VILLAGE OF KIMBERLY, WI
NOTICE OF VILLAGE PLAN COMMISSION MEETING

ITEM DESCRIPTION: Aspire Phase 2 Site & Building Plan Review

Re: Site Plan & Stormwater Management Plan Review
Aspire-Phase II (Heritage-MSP Kimberly)
McM. No. K0001-09-24-00338.04

AS-1.0

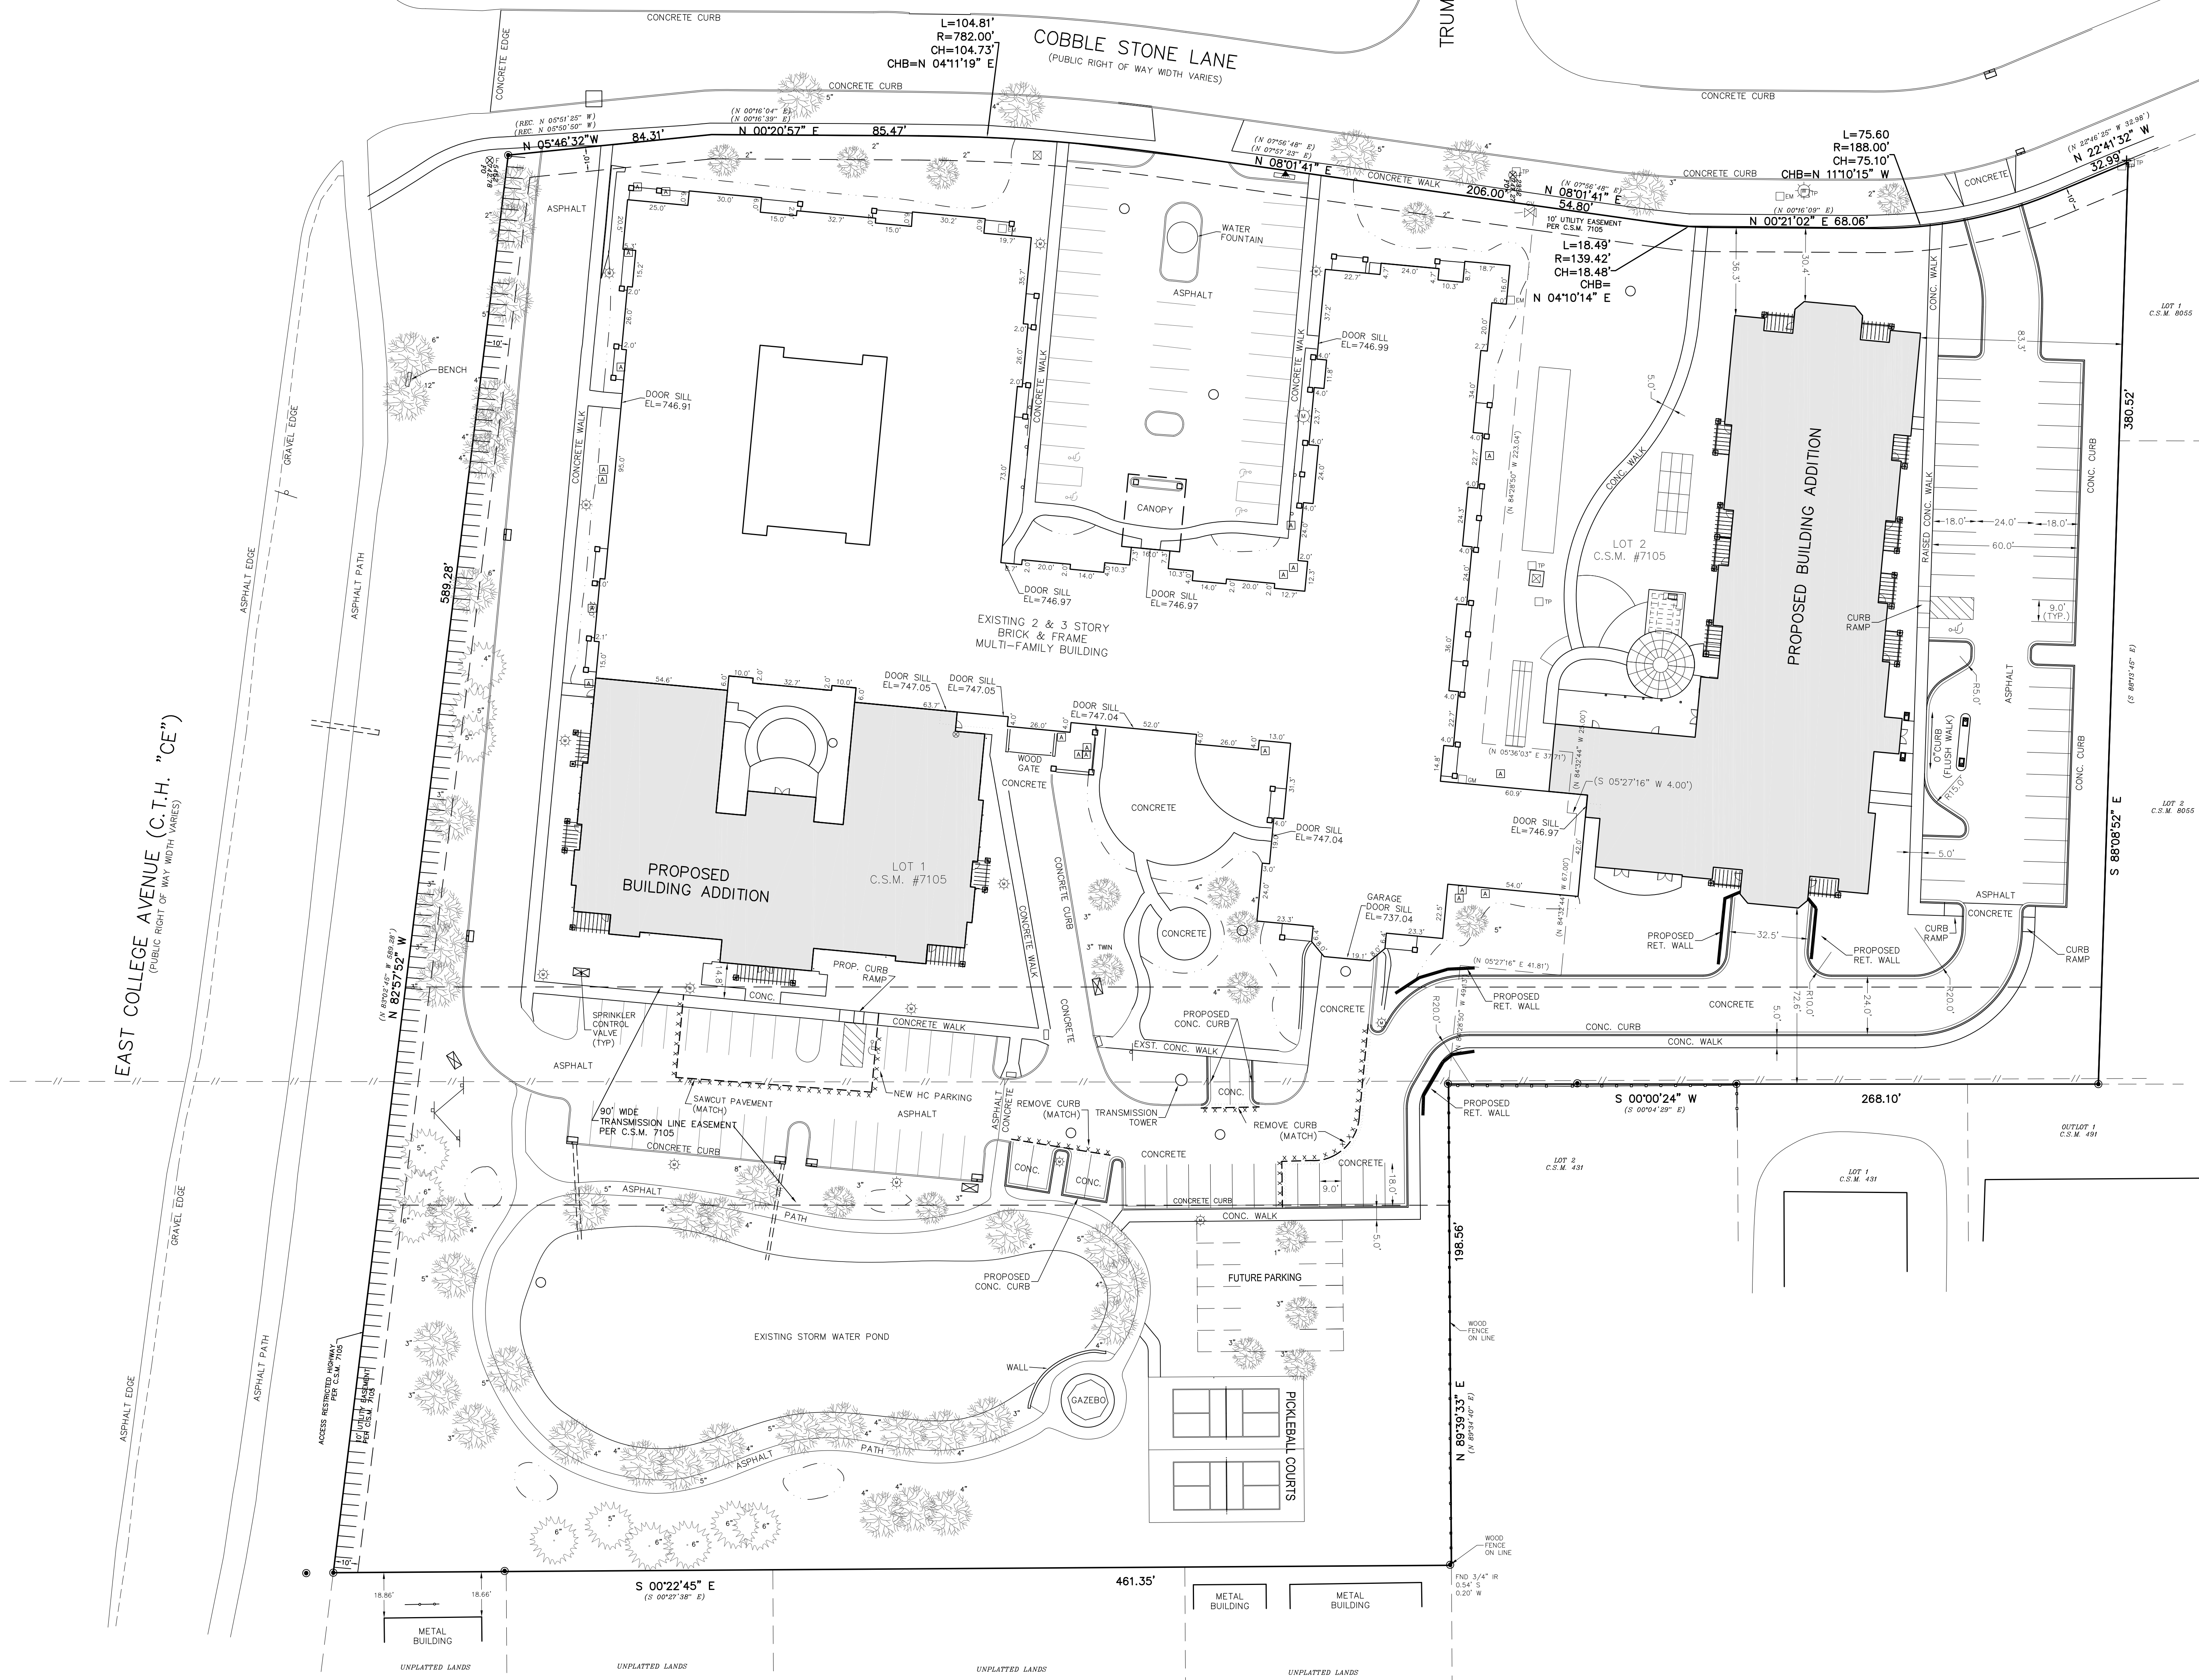
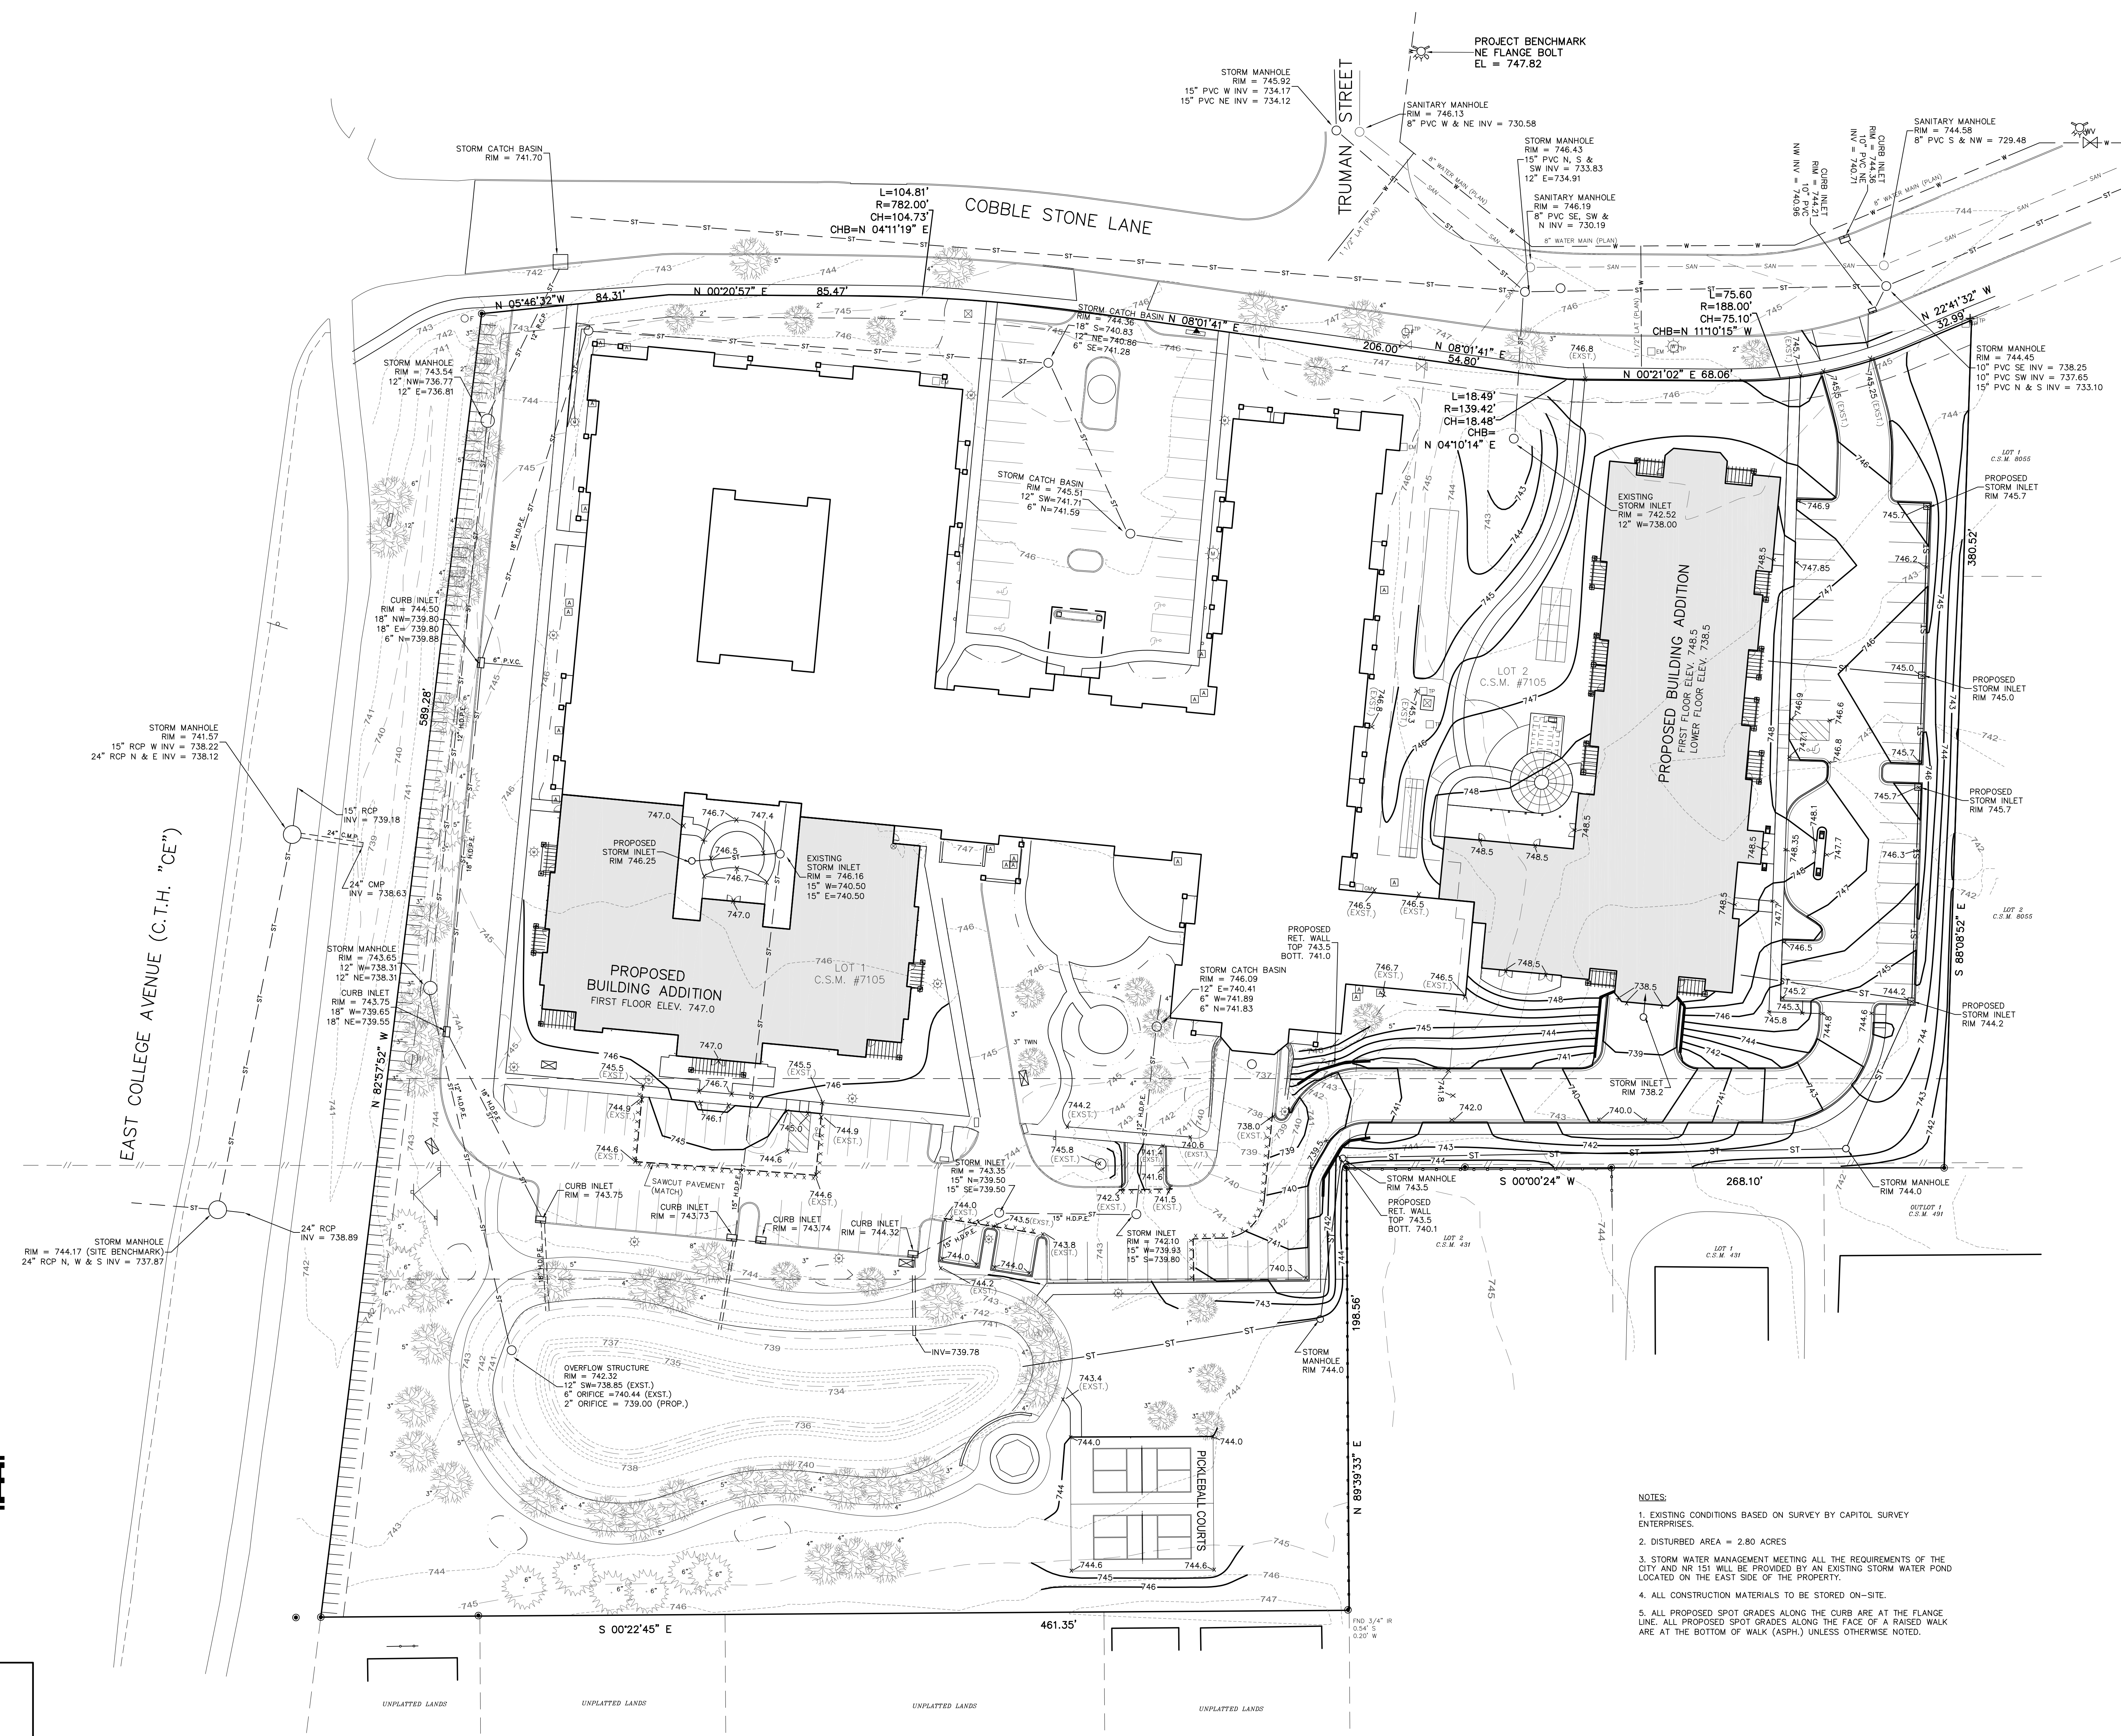
- Setbacks** – compliant.
- Parking** – No setbacks required. Complaint with municipal code requirements. See top right corner of “Site Plan Review Submittal” plan set. Historic on-street parking concerns, therefore staff is requesting additional stalls added to the most north-western lot. See review comments.
